MINUTES: Thursday, 30 July 2020. Rm 3.11 50 Victoria St, Wellington and Microsoft Teams Meeting

Agenda: principal items

V2, 30 Jul 2020

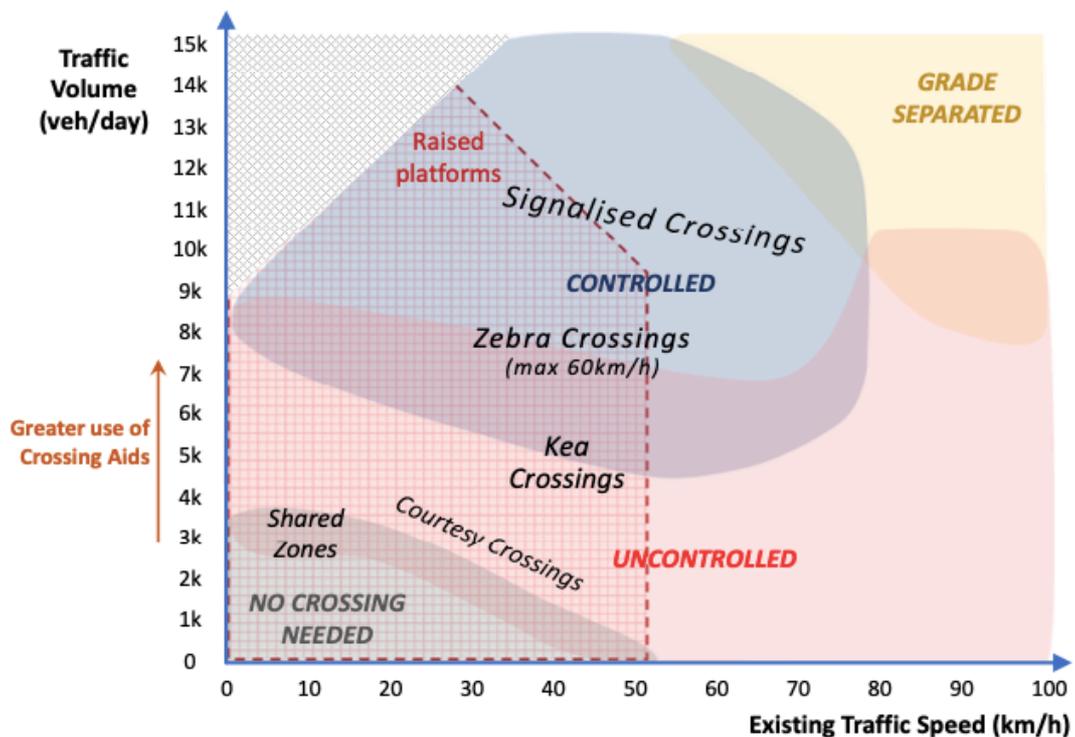
It was agreed that this needed refinement. Platforms would be unlikely to be needed where no crossing was needed or within Shared Zones or where existing traffic speeds were <30kmph. Whether a crossing with over 8,000 vehicle/day and

existing traffic speeds >80kmph would be uncontrolled was open to doubt. A Shared Zone with existing traffic speeds of >40kmph was viewed with some misgivings and it was felt that Courtesy Crossings should be restricted to traffic volumes <4,000 vehicles/day and existing traffic speeds <30kmph. Peak volume, rather than average, would be the better determinant. Pedestrian traffic volume would also be a determinant.

It was agreed that thought also needs to be given to the implications arising from the rule changes resulting from Accessible Streets, Innovating Streets and the side-road give way changes. Further comments were sought from members.

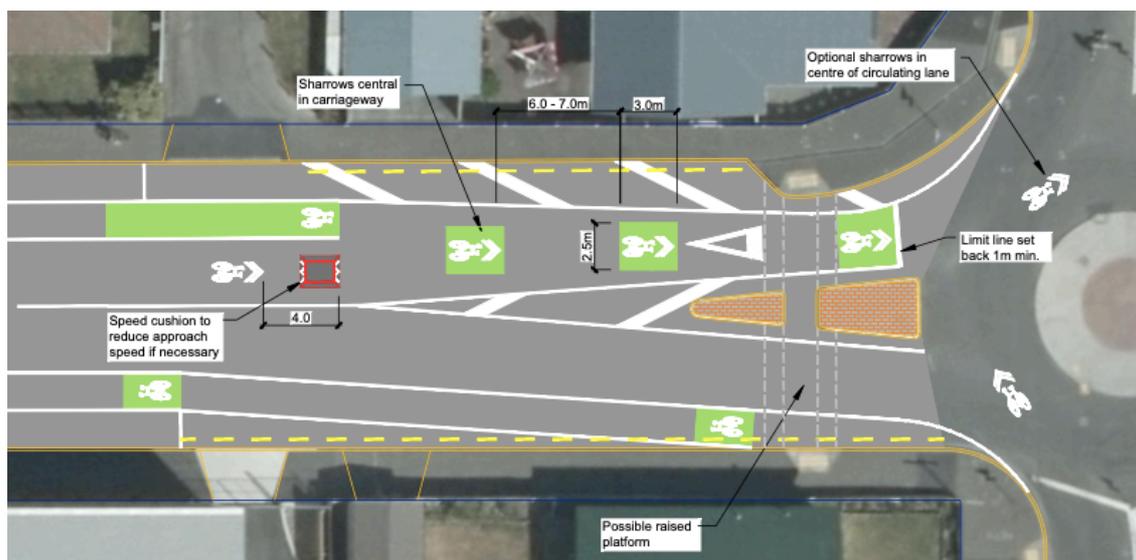
Placing the green block and sharrow at the limit line was preferred, as this would give motorists passing in front of it a visual cue to watch for cyclists. The first sharrow without green was agreed to be confusing and unnecessary. Closing the entry to a cycle lane with a white line was incorrect.

Marking sharrows within roundabouts had proven to be too difficult to maintain, because the action of the tyres quickly obliterated the markings, while shifting the markings into the debris zone to extend their life would diminish both the message to motorists and the level of service for cyclists tracking the markings.

Indicating the installation of a speed cushion as an integral part of the layout was considered unnecessary and potentially less safe for cyclists, if motorists were likely to avoid it by entering the cycle lane to go around the cushion.

It was agreed that the use of the sharrow marking would require the location to meet the parameters for the marking in the guidance.

Glen Koorey will revise the design to reflect the comments.
